## **APPENDIX F – Hydrology**

# Comrie and Dalginross Flood Study

## Baseline Design flows and Water Levels

## *5) SEPA Comments and Mouchel Response*

Figure 5: Locations where the model and recorded water levels are compared

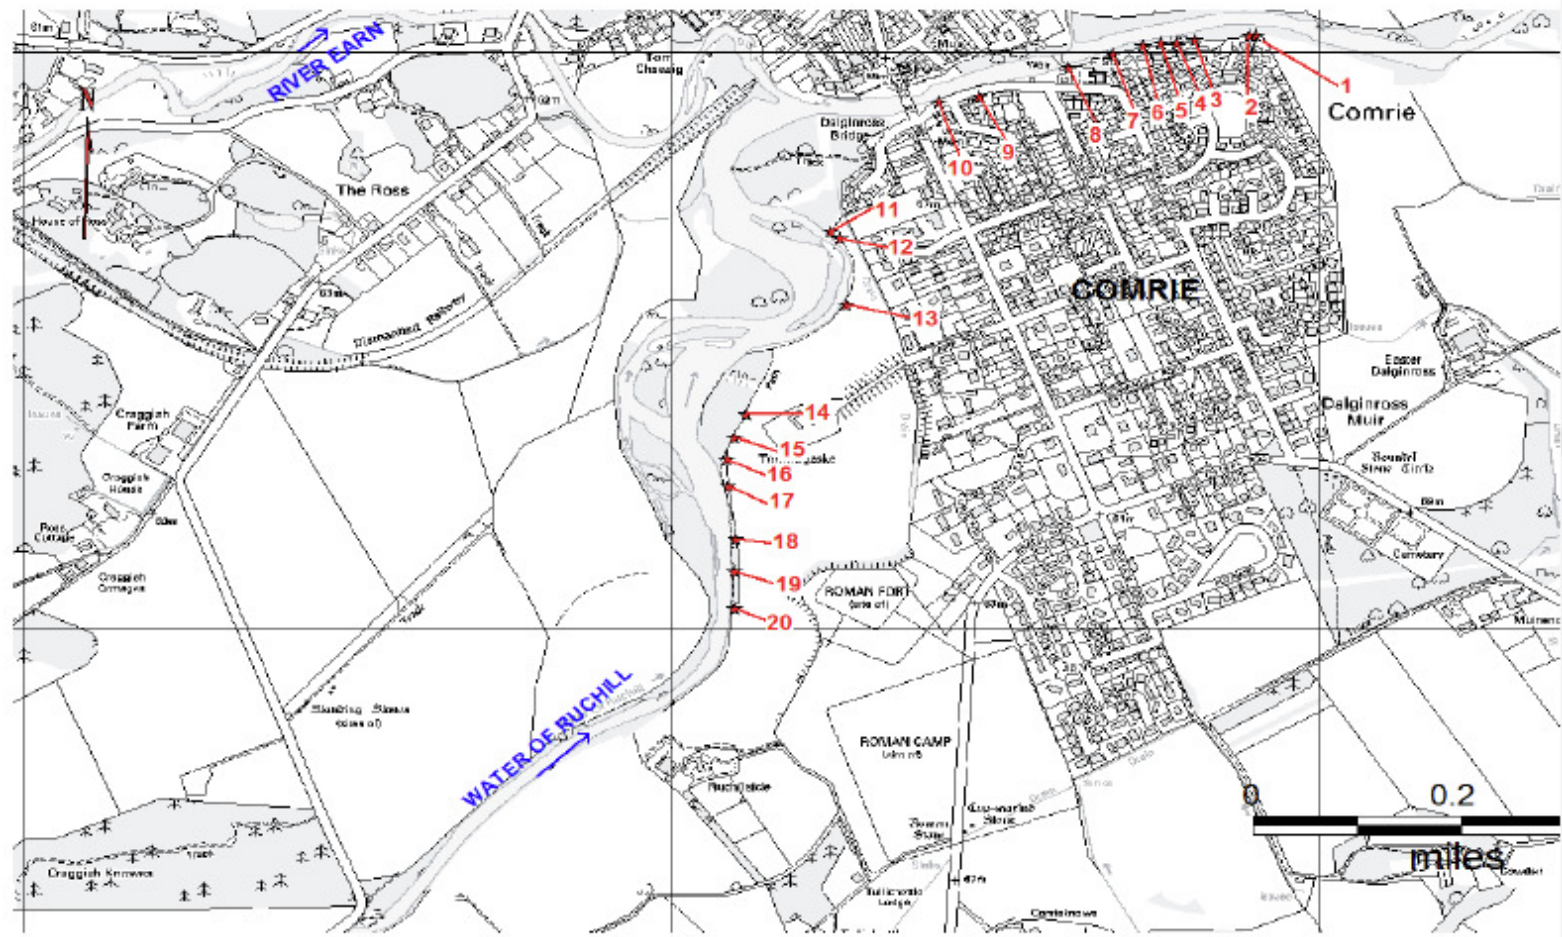
The modelled water levels (scenario 5 with and without flow constraint at Dalginross) were compared with the post-flood survey levels for the 1997 event.

The post-flood levels vary between the 50 to 200 year levels as given by the scenario 5 (without flow constraint  $m^3/s$  at the Dalginross) model. However, it is evident that the RP is very sensitive to water level.

Comaprison of Arup's recorded water level and Mouchel's model water levels- February 1997 Event

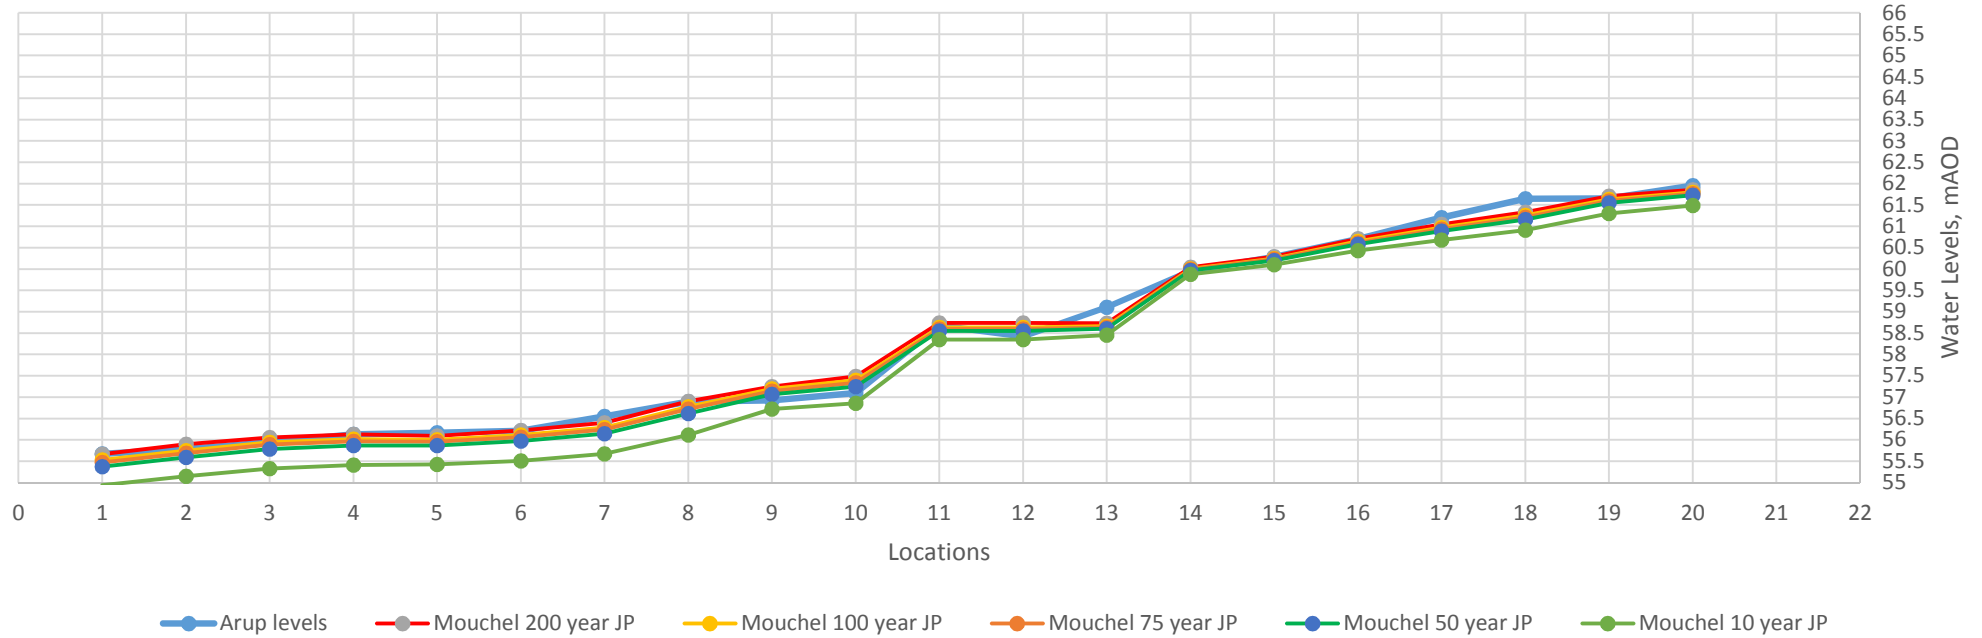
A chart showing comparison of Arup's and Model results (scenario 5 without flow constraint at the Dalginross gauge is presented below:
